DRAWING AMENDMENTS

DETERMINED PLAN

CONVERSION OF GROUND FLOOR TO CAFE, SHOP, RENEVATION OF UPPER FLOORS TO FORM 1 FLAT.
22 FLEET ST., HOLBEACH — MR & MRS T.P. COX

DRG. No C46108105 & PE

GROUND FLOOR PLAN

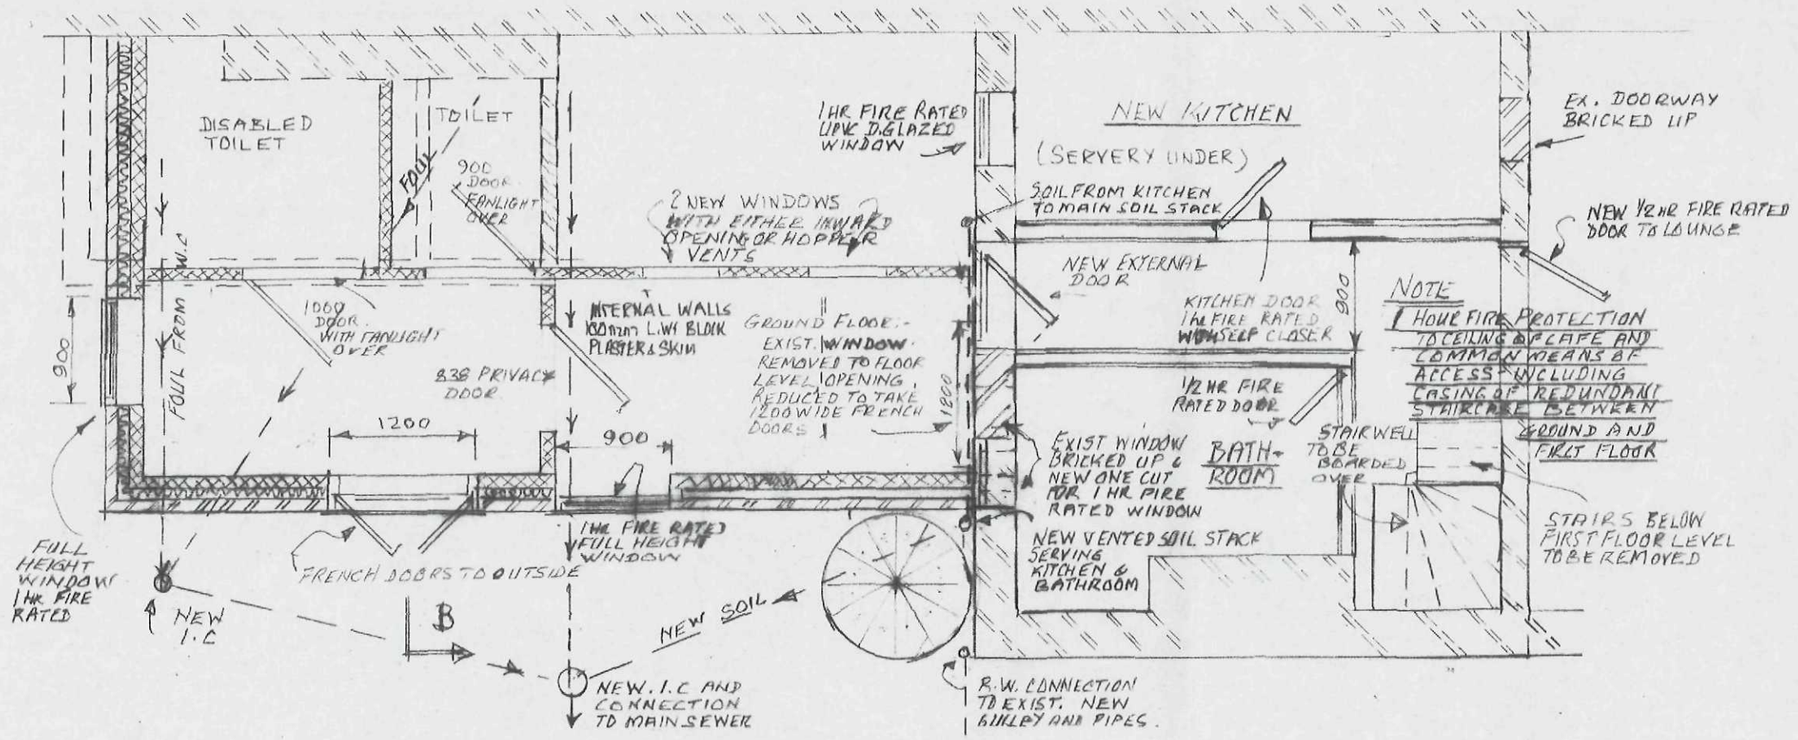
- PREVIOUS REFERENCE TO LOWERED FLOOR IN KITCHEN SHOWN NOW NOT RELEVANT
- POSITIONS OF KITCHEN & BATHROOM REVERSED.
- HALL & ENTRANCE HALL REVERSED
- EXIST DOOR TO LOUNGE BRICKED UP AND NEW DOOR LOCATED IN NEW HALLWAY.
- ALTERATIONS MADE TO LOCATION AND ROUTES OF SOIL DRAINAGE TO FIRST FLOOR KITCHEN & BATH. WASTE FROM KITCHEN CARRIED UNDER FLOOR TO SOIL STACK AND BATHROOM WASTE CARRIED ABOVE FLOOR & THEN EXTERNALLY TO NEW STACK

- FLOOR OF KITCHEN ON GROUND FLOOR RAISED TO SAME AS REMAINDER

PLAN ON FIRST FLOOR - (PART)

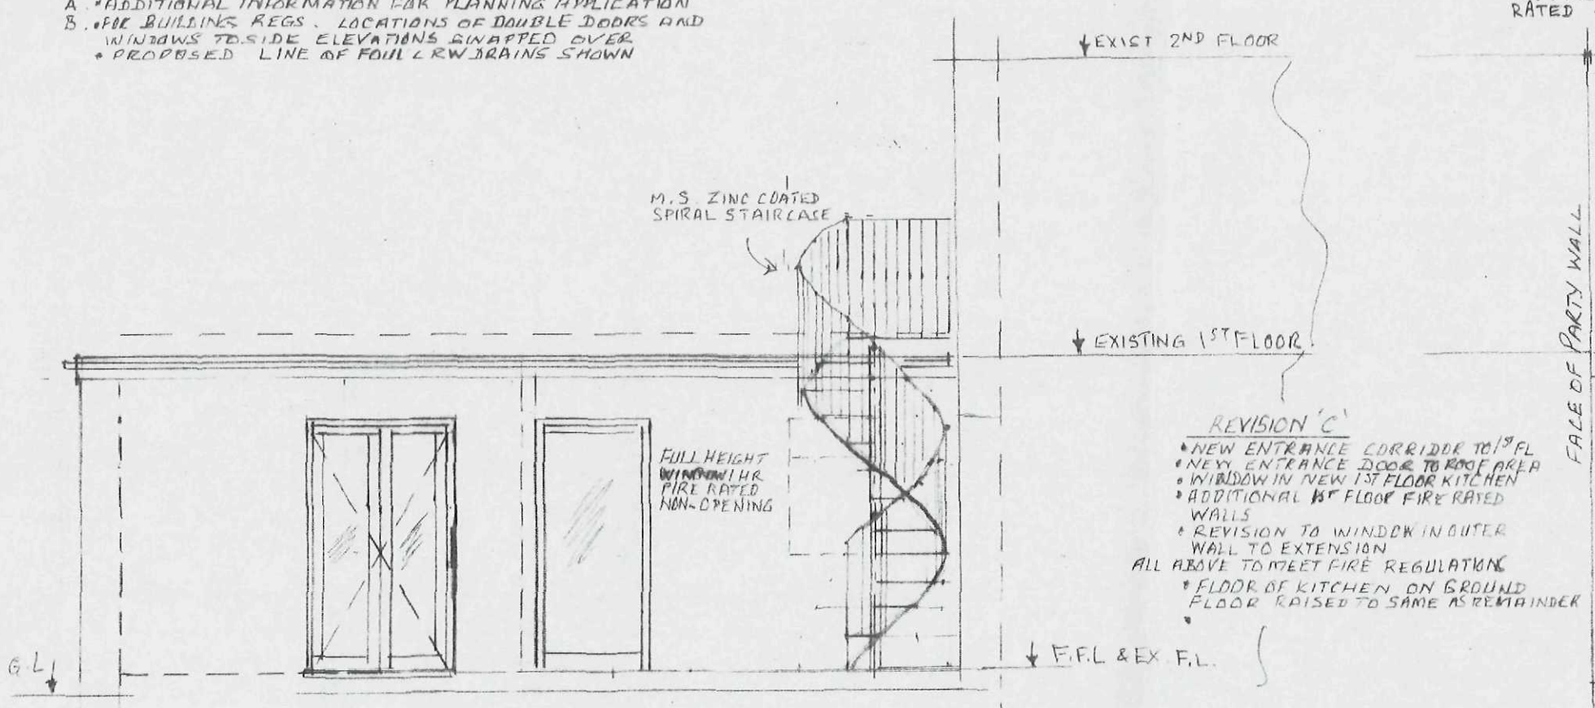
- KITCHEN WINDOW WIDENED TO PROVIDE MORE LIGHT TO KITCHEN

- NEW ENTRANCE CORRIDOR TO 1ST FL
- NEW ENTRANCE DOOR TO ROOF AREA
- WINDOW IN NEW 1ST FLOOR KITCHEN
- ADDITIONAL 1ST FLOOR FIRE RATED WALLS
- REVISION TO WINDOW IN OUTER WALL TO EXTENSION

ALL ABOVE TO MEET FIRE REGULATIONS
